Environmental Impact Assessment

Screening according to Schedule III of S.L. 549.46

ERA Reference no.: EA/00006/25
PA Reference no.: N/A
Project Title: Wied Dalam Park.
Location: Ghar Dalam - Triq Ghar Dalam, Birżebbuġa.
Screening date: July 2025

Figure 1 – Proposed plan (Source: PDS)

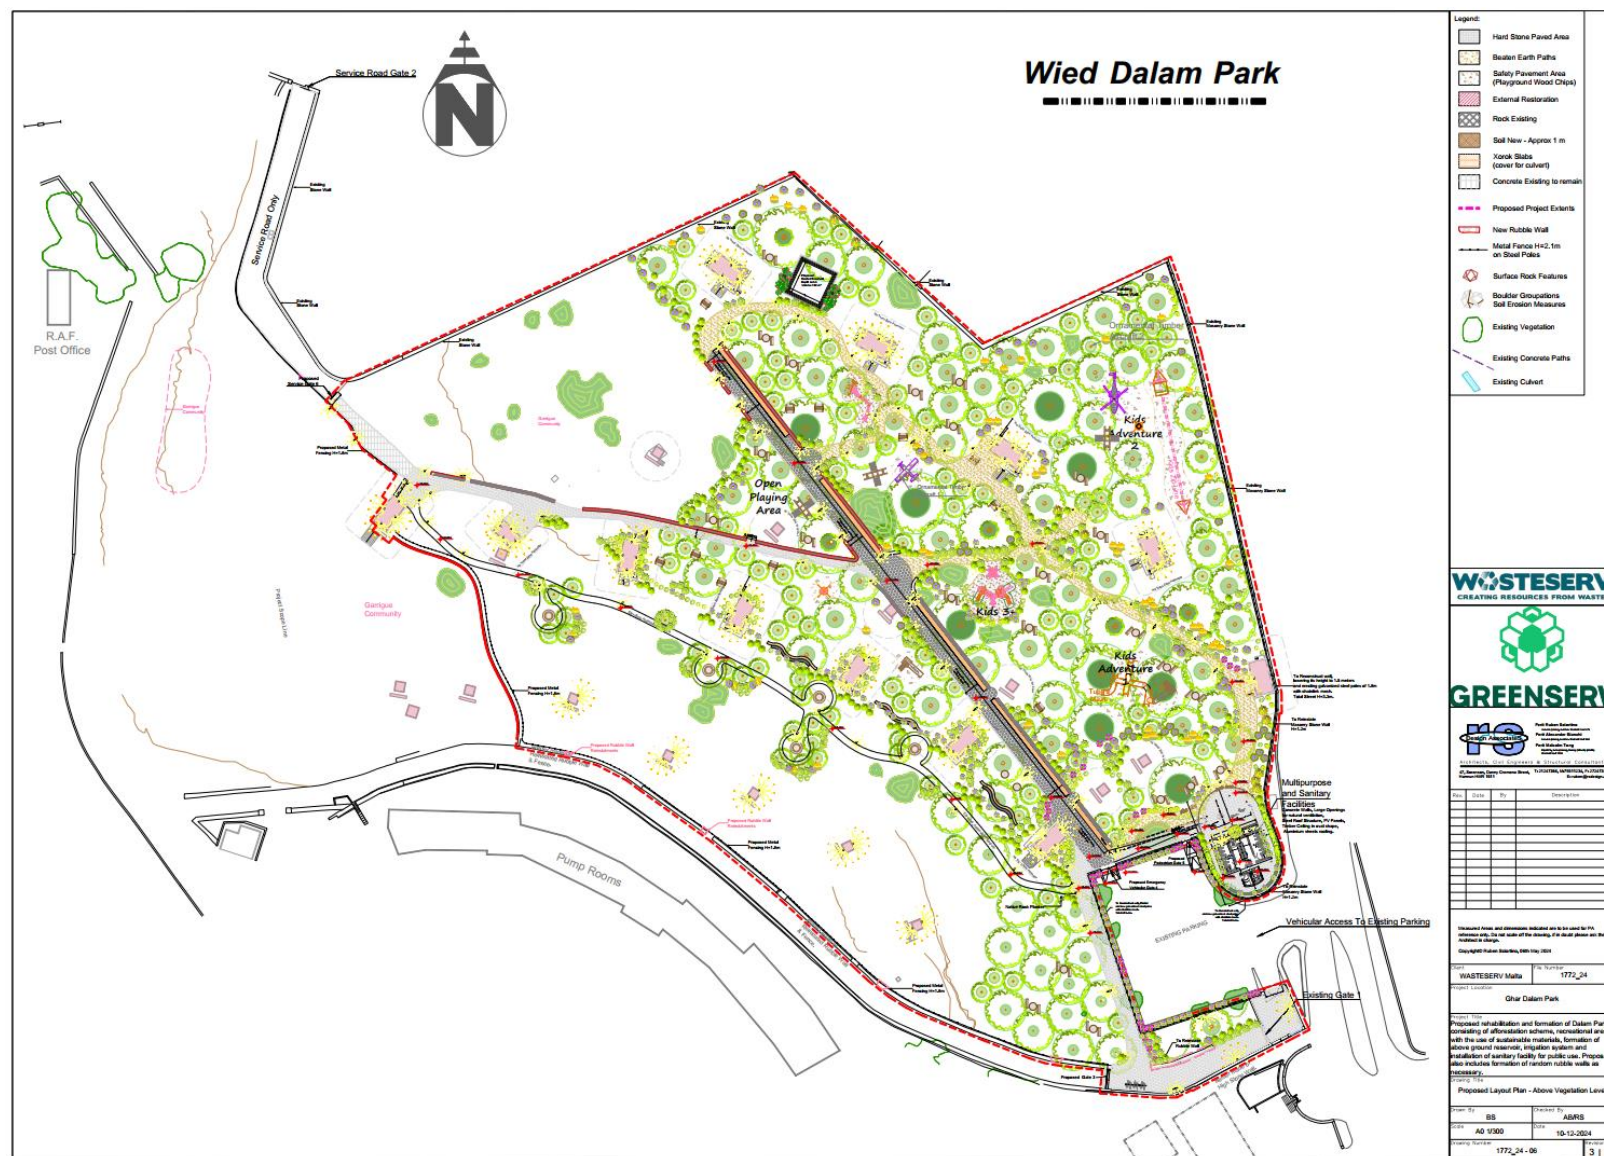
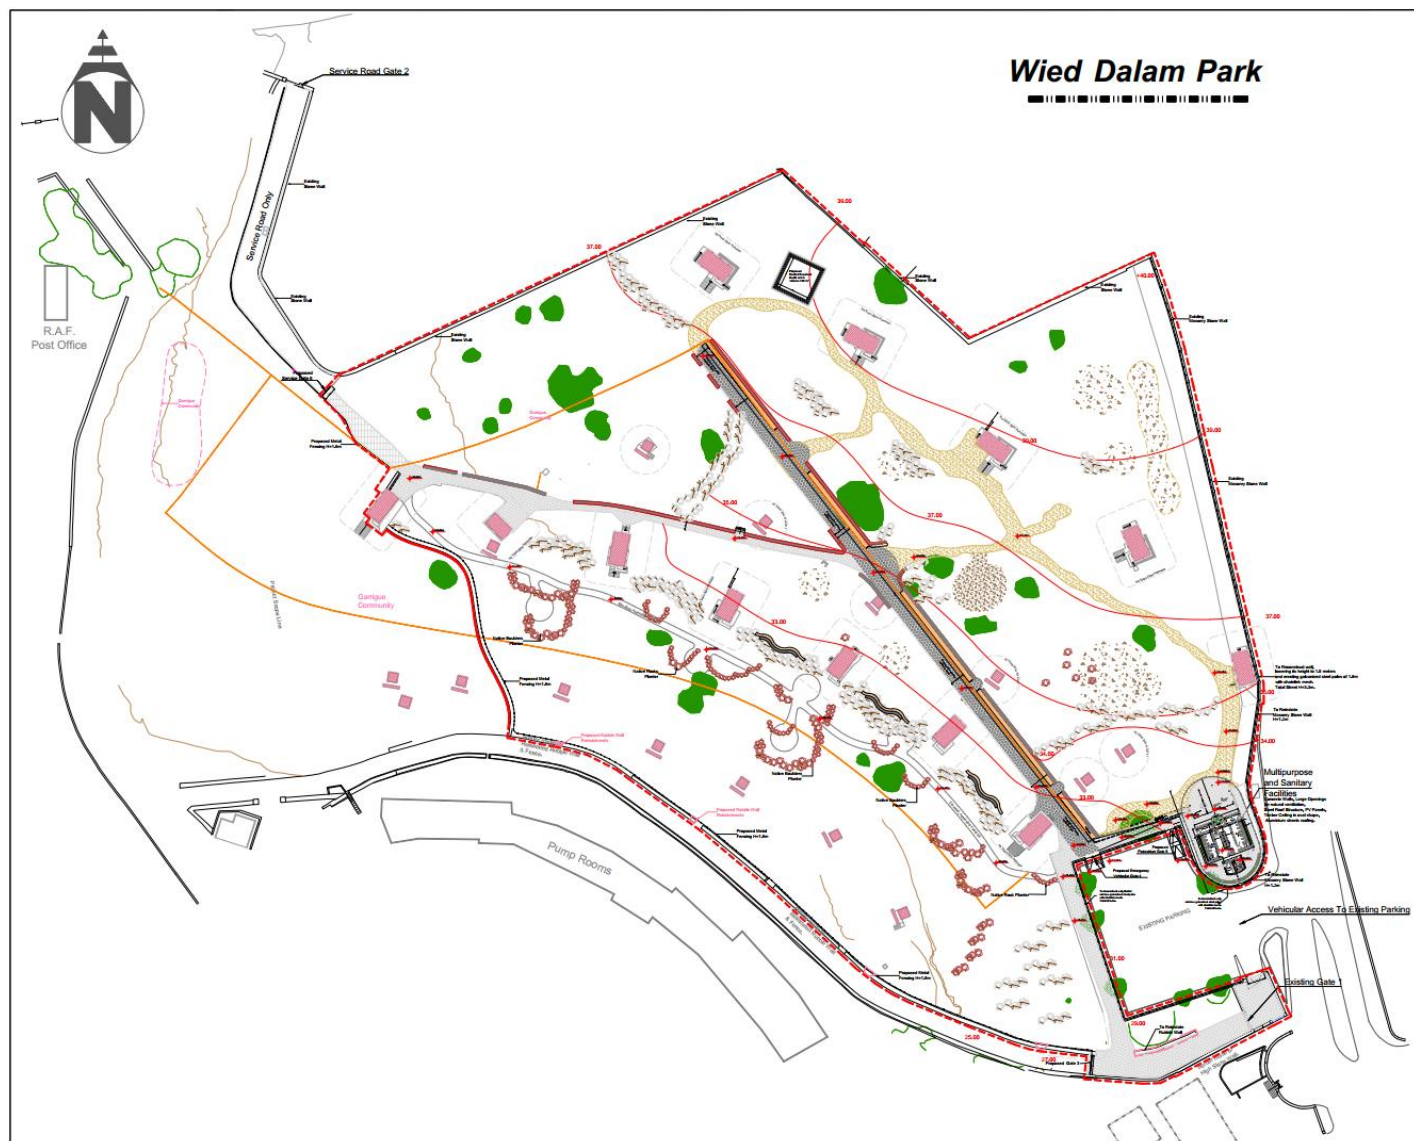
- 1.1 The proposal aims to transform a 30,000 m² area of Wied Dalam, which includes a large number of disused underground British-era fuel storage reservoirs, into a family park focussed on green open space, biodiversity and social engagement (see Figure 1).

- 1.2 The existing fuel storage tanks embedded into the bedrock and their ventilation structures will be retained and integrated within the park, in view of their industrial heritage value. This will be supported by educational initiatives, tours, displays and signs to explain their historical context and importance.

- 1.3 The proposed park includes a network of footpaths, seating areas, open green zones and children's play areas.
- 1.4 Existing invasive species will be removed and rubble walls restored/constructed (where needed for soil retention, erosion protection). Existing garrigue and grassland communities in the lower part of the site will be preserved, and degraded ecological zones will be improved, aiming for the establishment of *Oleo-Ceratonion* habitat.

Figure 5 – Outline of cave complex in relation to the site of the proposal (Source: ERA MEPS Portal)

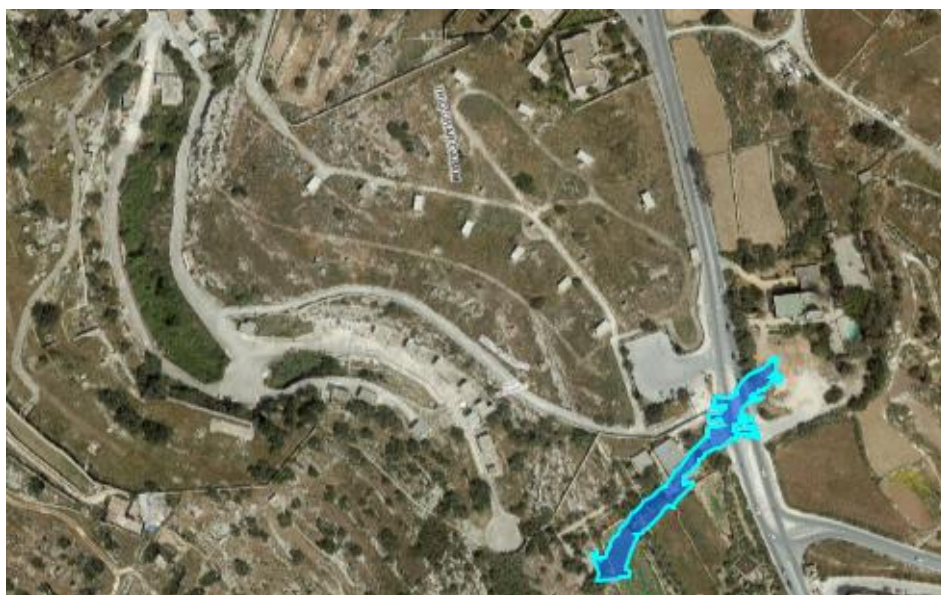
7.1 The cave complex is situated in close proximity to the site, and its opening is situated close to the bottom of the valley, however, it does not face the site directly (Figure 5).

7.2 As mentioned above in section 6; the proposal does not include any significant ground interventions and noise/light disturbance are expected to be limited, hence, no particular construction-phase effects affecting the cave are envisaged. During operations, visitors will access the site from the existing car parking, and there would be no direct interaction with the cave entrance.

7.3 With specific reference to the bats inhabiting the cave and using the valley areas as foraging grounds, since the park will be closed at night, no operational lighting within the site is expected after opening hours, thus no disturbance to the bats' nocturnal activities is envisaged.

7.4 The project is considered unlikely to affect the integrity of the protected cave complex and its inhabiting species.
